Project Building Name / # Portland Building
 Project Address or Location 1134 SW 3rd Ave, Portland, OR 97204
 Project Name and Description Portland Building Terracotta, earth sealant lab study / Testing
 Total Project Value Project Reference #/Billing ID #

17-251284 REV 01 FA

Re: Portland Building Terracotta Tile Panel Sealant Load Testing

PORTLAND BUILDING TERRACOTTA
1134 SW 5TH AVE
PORTLAND, OR 97204
17-251284 REV 01 PA
SHEET TITLE: STRUCTURAL GENERAL NOTES LEGEND & ABBREVIATIONS
SHEET NO. SI.1

PLAN

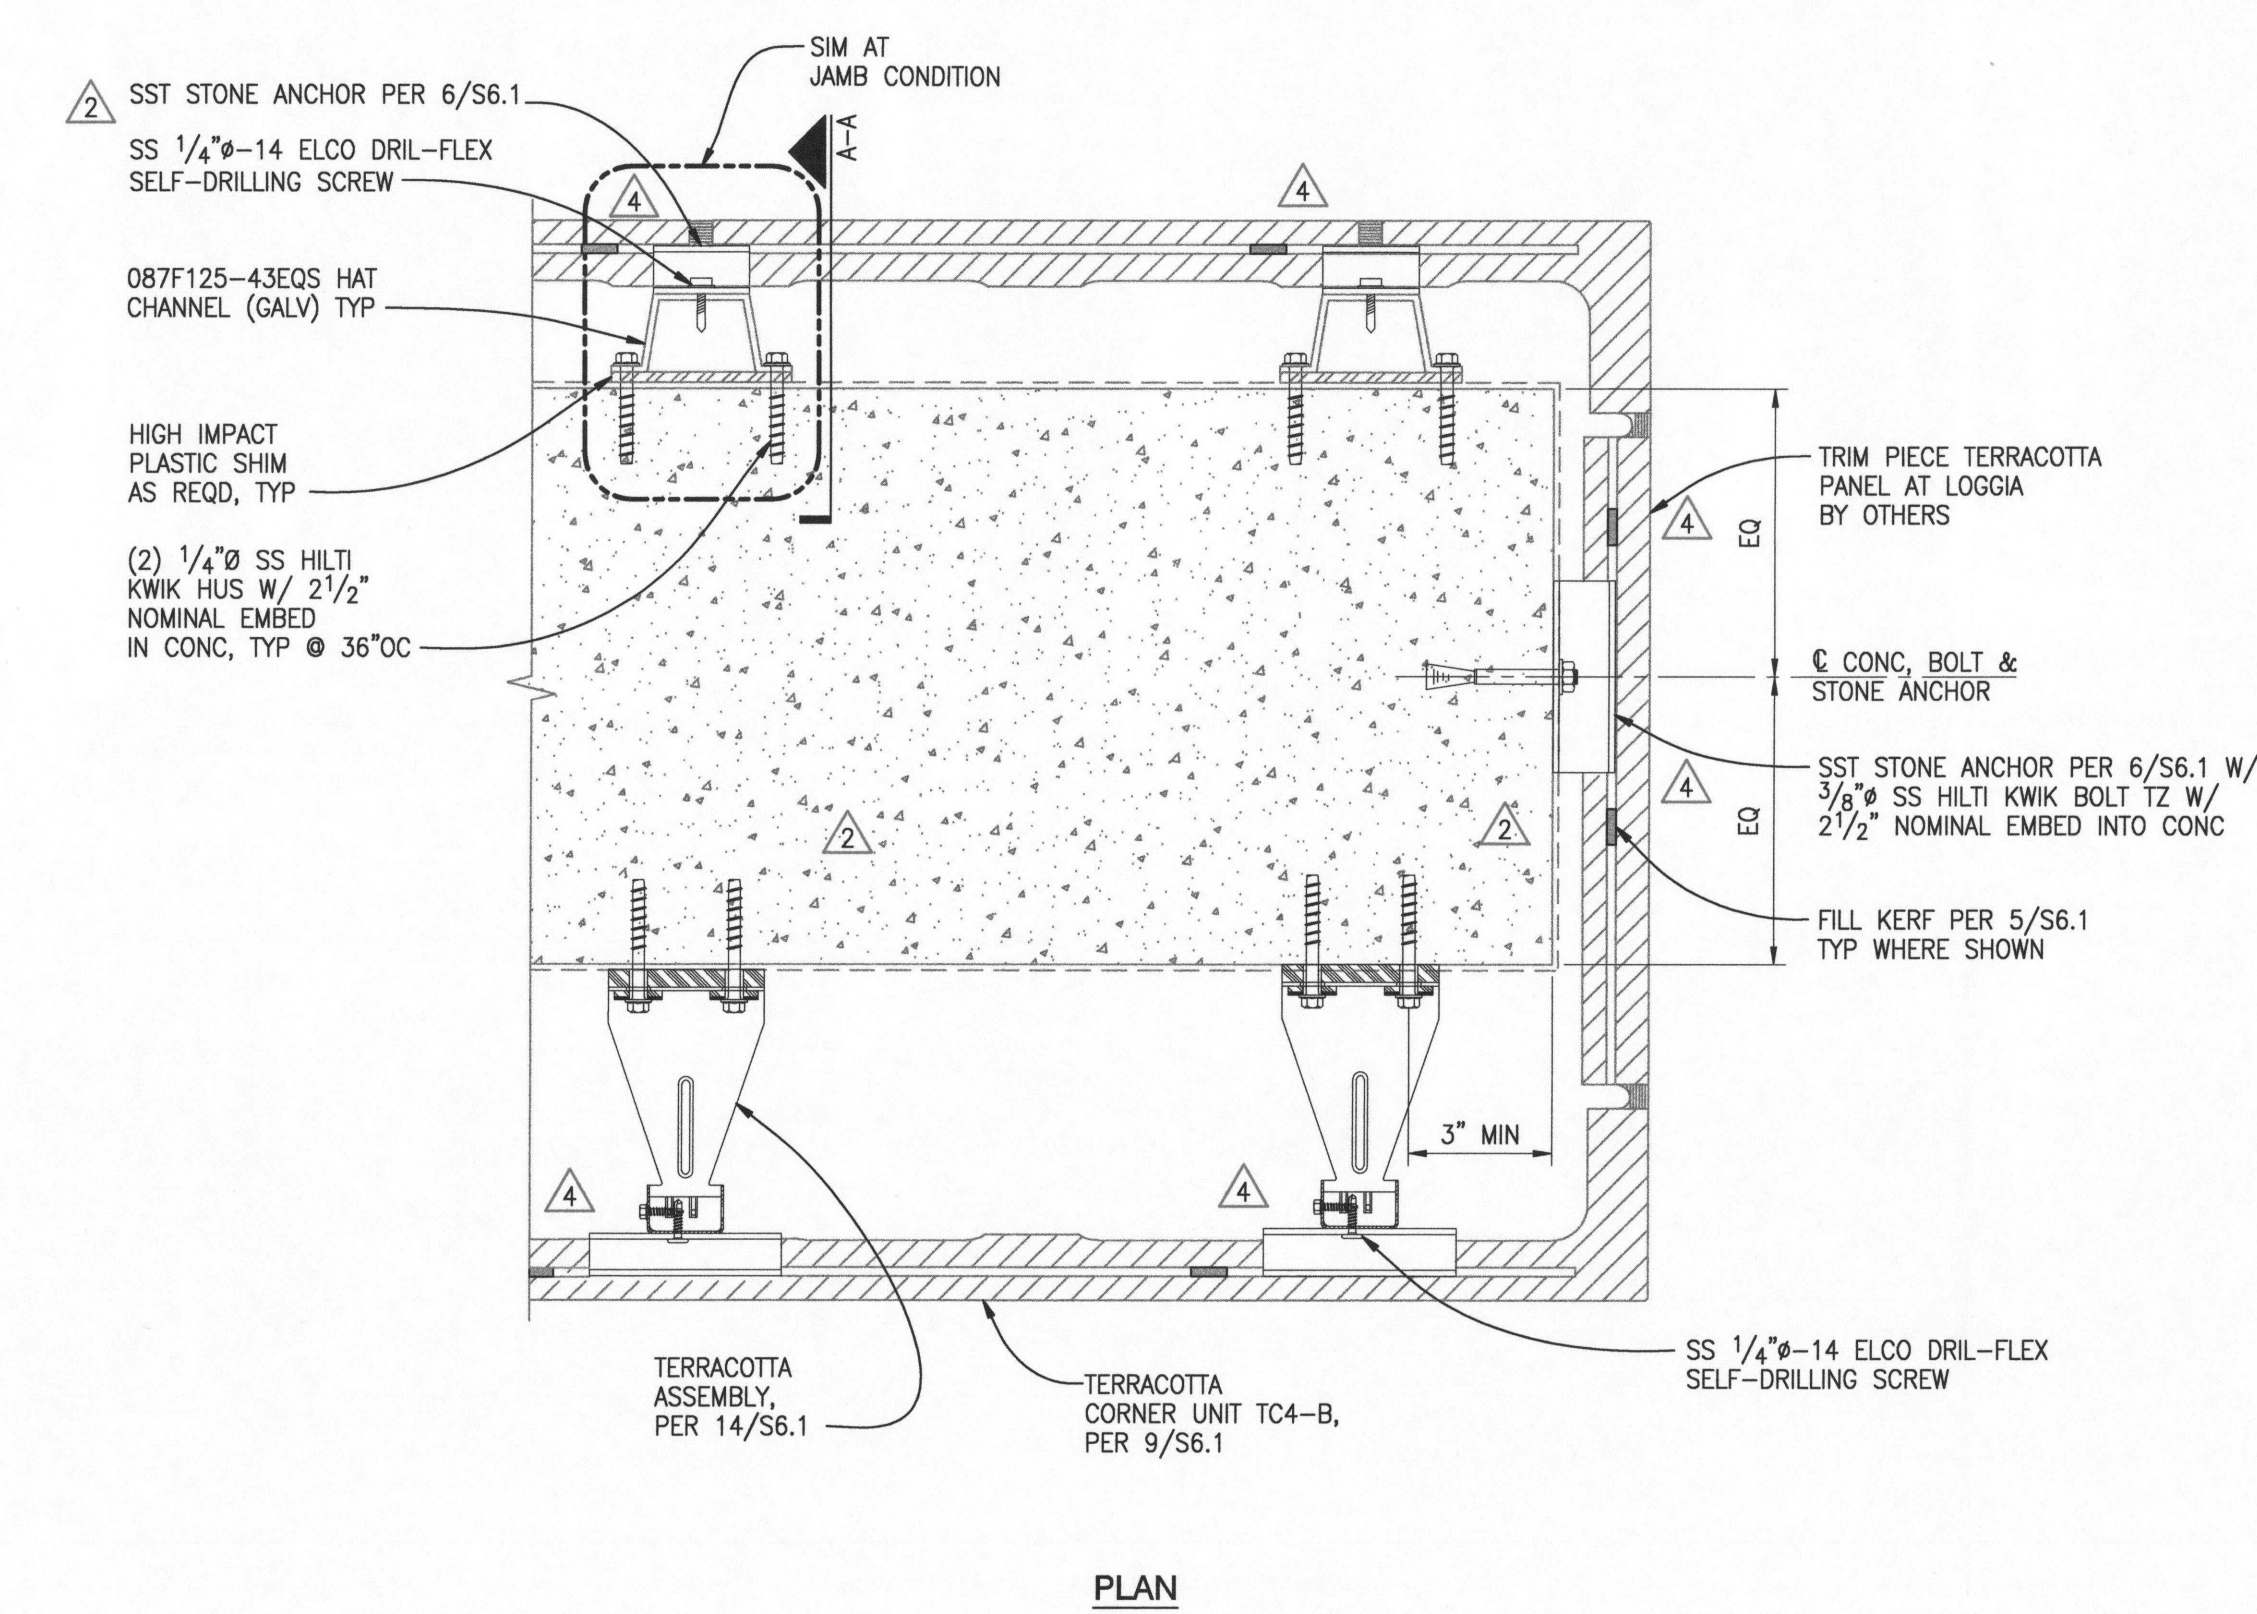
NOTE:
1. PROVIDE A GAP OF $\frac{3}{4}$ " MIN AT THE KERF BETWEEN EPOXY AND STONE ANCHOR BRACKET.

PLAN - TERRACOTTA AT PIER/PILASTER

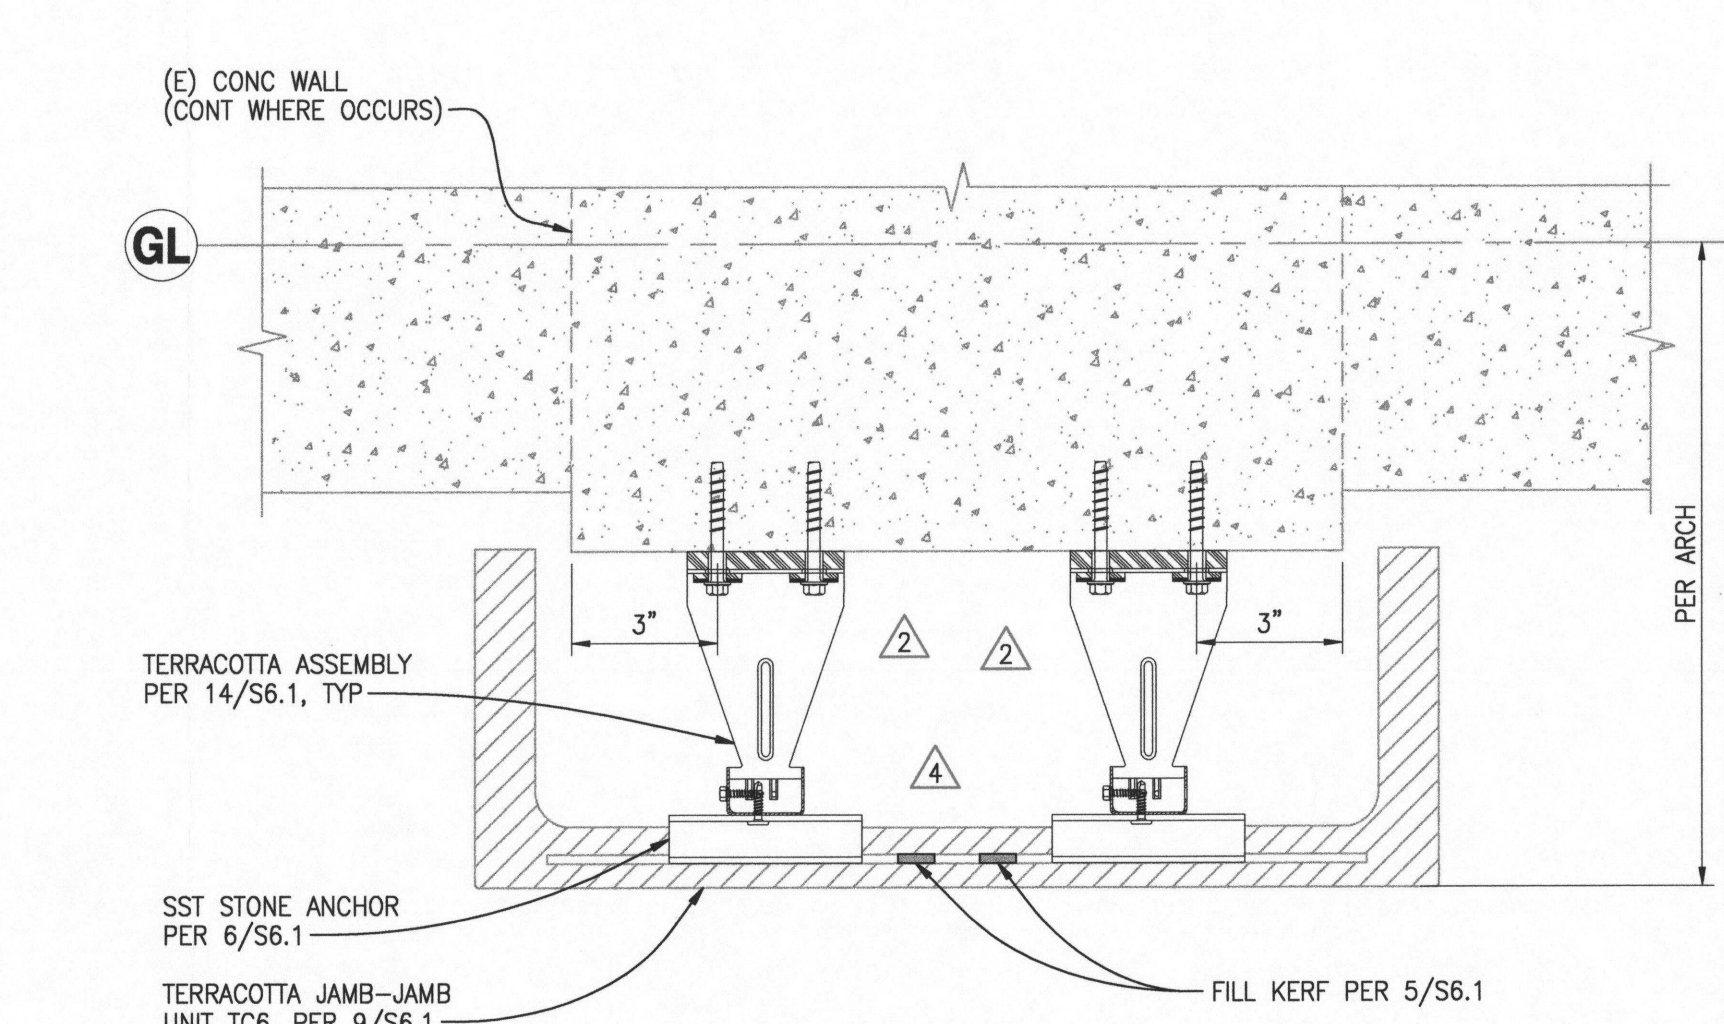
NOTE:
1. ADDITIONAL INFORMATION PER 1/S56.1
2. PROVIDE A GAP OF $\frac{3}{4}$ " MIN AT THE KERF BETWEEN EPOXY AND STONE ANCHOR BRACKET.
